CAP MEETING – 12 March 2025

ITEM 8.1

<b>DEVELOPMENT NO.:</b>	23034790
<b>APPLICANT:</b>	David Crawford
<b>ADDRESS:</b>	644 PARACOMBE RD PARACOMBE SA 5132
<b>NATURE OF DEVELOPMENT:</b>	Construction of single storey detached dwelling & associated landscaping and change of use of existing dwelling to tourist accommodation
<b>ZONING INFORMATION:</b>	<p><b>Zones:</b></p> <ul style="list-style-type: none"> <li>• Productive Rural Landscape</li> </ul> <p><b>Overlays:</b></p> <ul style="list-style-type: none"> <li>• Environment and Food Production Area</li> <li>• Hazards (Bushfire - High Risk)</li> <li>• Hazards (Flooding - Evidence Required)</li> <li>• Limited Land Division</li> <li>• Mount Lofty Ranges Water Supply Catchment (Area 1)</li> <li>• Native Vegetation</li> <li>• Prescribed Water Resources Area</li> <li>• Water Resources</li> </ul>
<b>LODGEMENT DATE:</b>	30 Nov 2023
<b>RELEVANT AUTHORITY:</b>	Assessment Panel at Adelaide Hills Council

**Response to Council's further information request letter  
Development Application ID: 23034790**

# Landscaping plan for fill batters

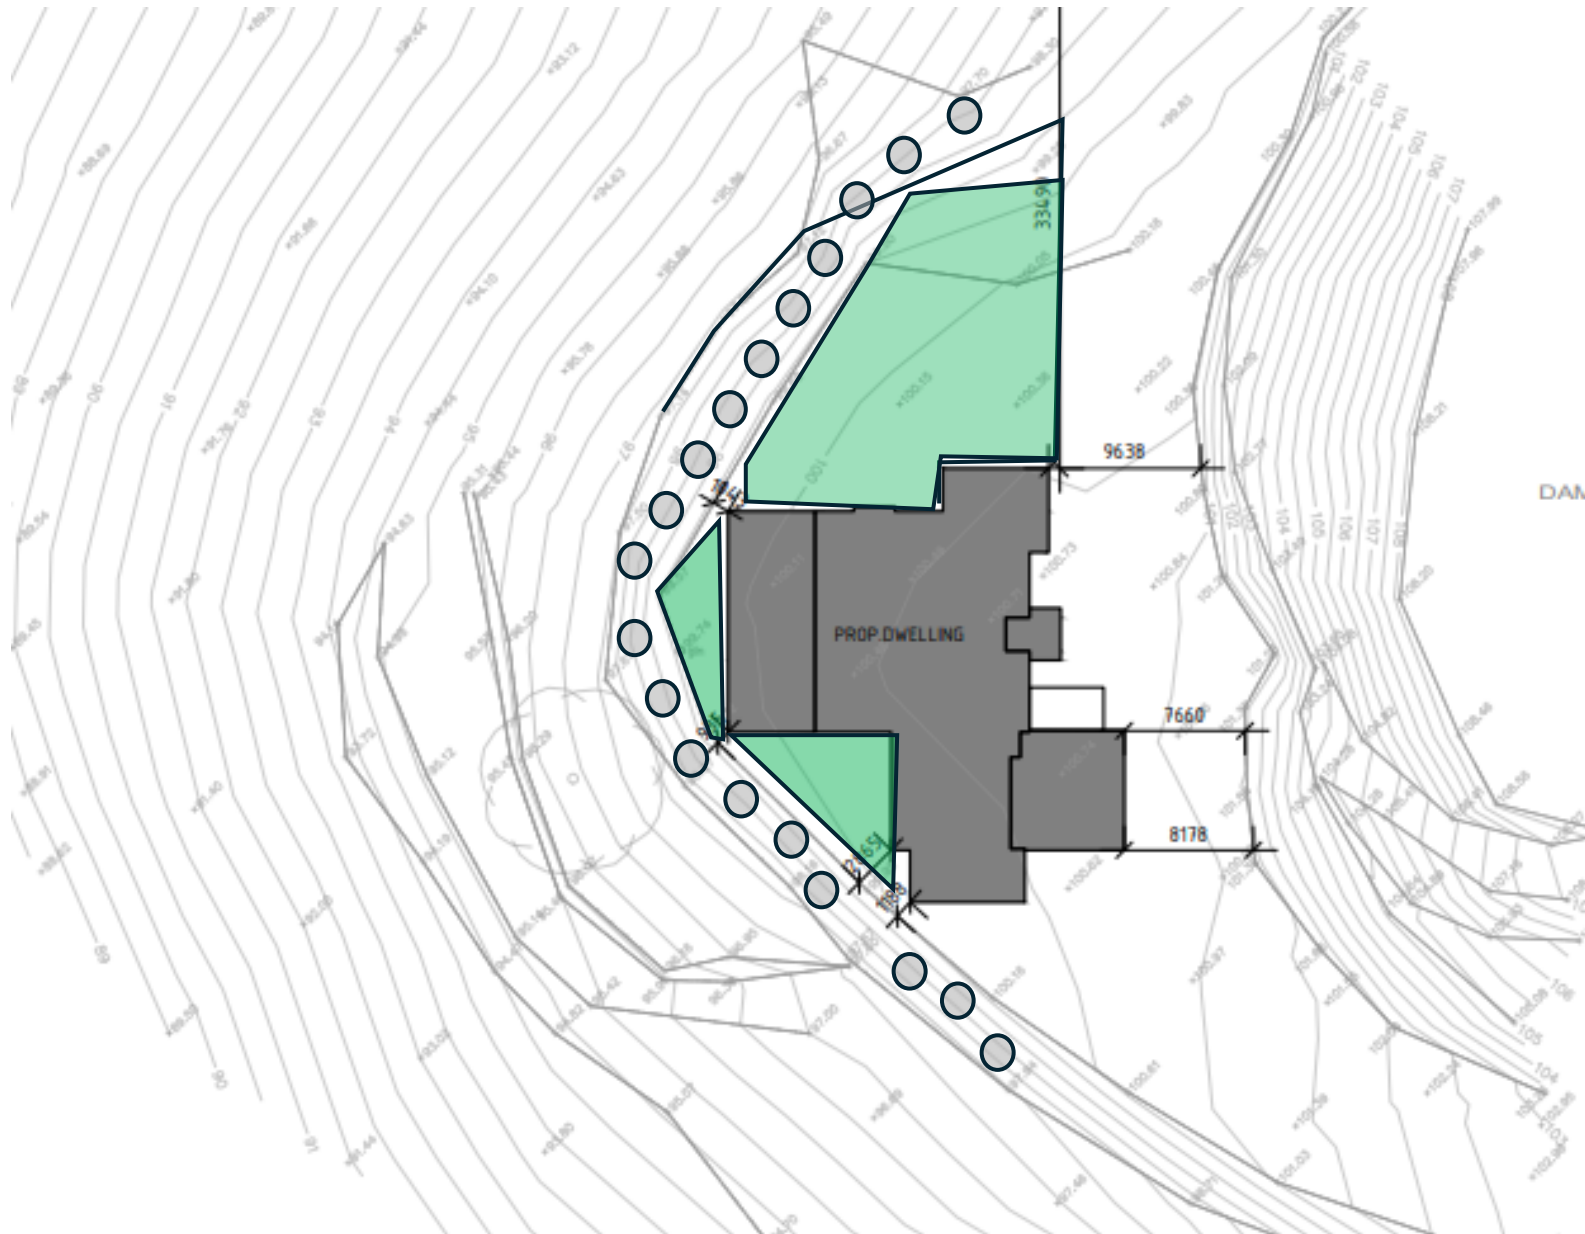
- 7 Landscaping plan for the fill batters has not been provided as requested. Preference is given to selecting plant species from Council's native habitat and landscaping guides: Native Gardens at Home o Adelaide Hills Council ([ahc.sa.gov.au](http://ahc.sa.gov.au)). Landscaping details provided on the amended plan are just indicative and surrounding the house. Council requires details for the landscaping of the batter area. Landscaping plan should be provided prior to CFS making their assessment to ensure that it is not contrary to their asset protection zone requirements.

Please find the attached landscaping plan which depicts kikuya grass surrounding the dwelling and soft mat-rush across the batter.

## Site Plan

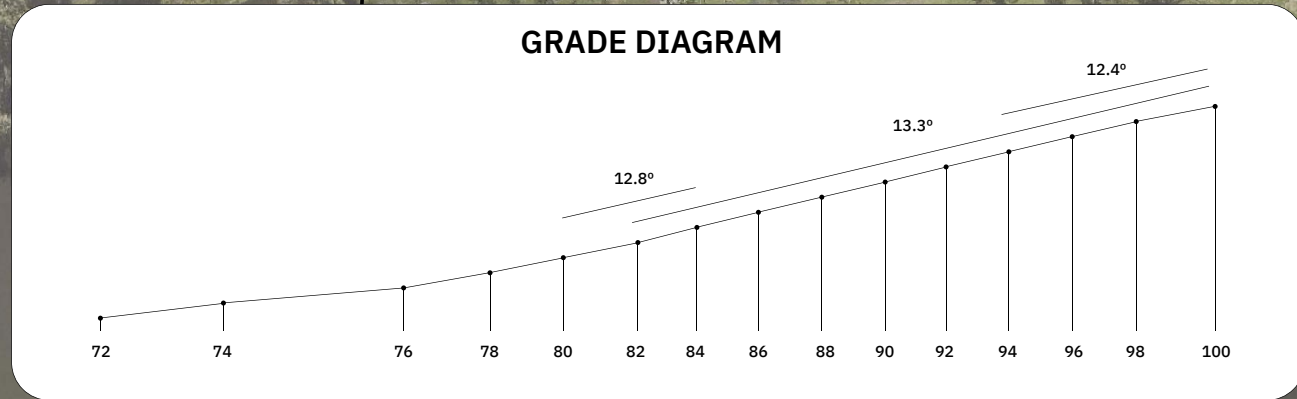
- 5 **Detail of water supply for the dwelling, minimum supply of 50,000 litres should be provided as envisaged by DPF 11.2 Part 4-General Development Policies-Infrastructure and Renewable Energy Facilities section of the Code. Also, the site plans and site drainage plan need to be consistent regarding the location, number and size of water storage tanks.**

- 6 Part of the new internal access track cuts through a water course. What modification to the water course are required to ensure that the works do not restrict the flow of waters. If a new culvert is proposed, then a more detailed site plan is required detailing the culvert and its location. Please also note that CFS in the RFI letter have also requested that a solid crossings over waterways shall be provided to withstand the weight of large bushfire appliances (GVM 21 tonnes).

Please find the culvert location on the attached site plan, which has already been installed. The culvert incorporates a 600-millimetre concrete pipe with a 9-metre by 2-metre by 0.15-metre 32mpa concrete slab, ensuring it is compliant with the GVM 21 tonne capacity required by the CFS. Please find the culvert depicted in the following photograph:
